**Environmental
Protection Agency**

**Re: River Run / Delaware County, Storm Water Inspection
Notice of Violation**

Figure 1: Sediment Trap not maintained

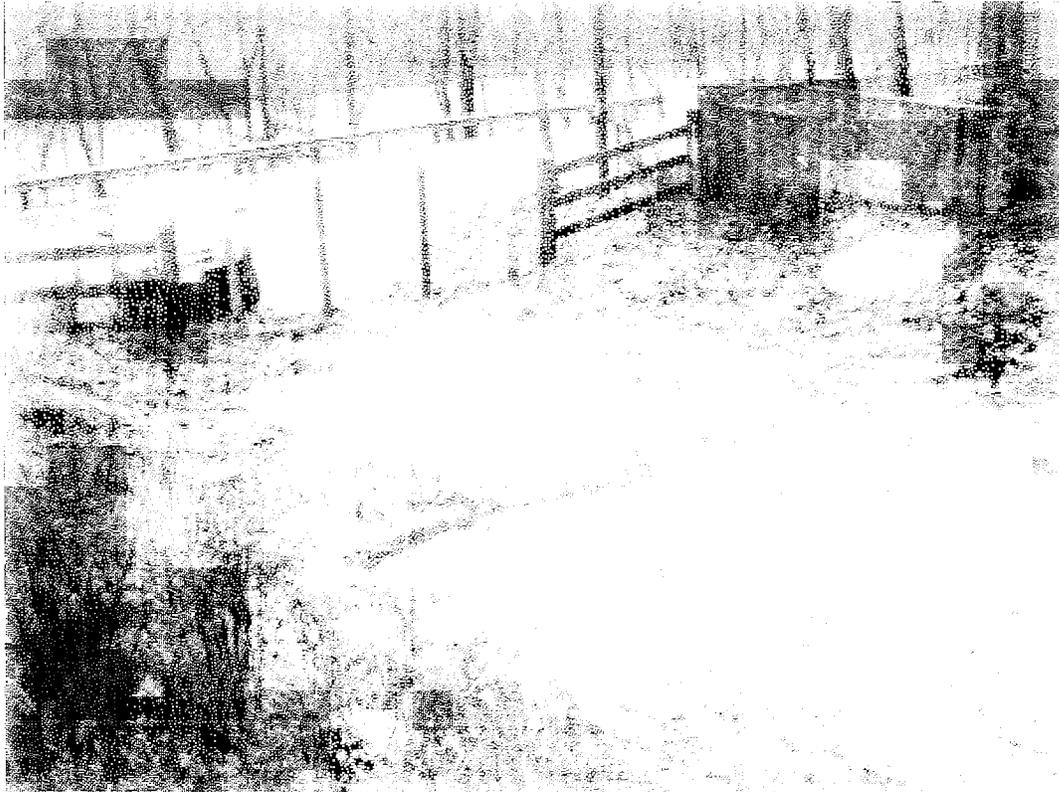
- The temporary emergency access road on State Route 315 is in the process of reclamation. As a result a temporary sediment trap was installed to minimize sediment laden discharges from the site. The trap was completely full resulting in a by-pass of storm water treatment (SEE PHOTO FIGURE 1 & 2). Failure to maintain controls is a violation of the General Storm water Permit.
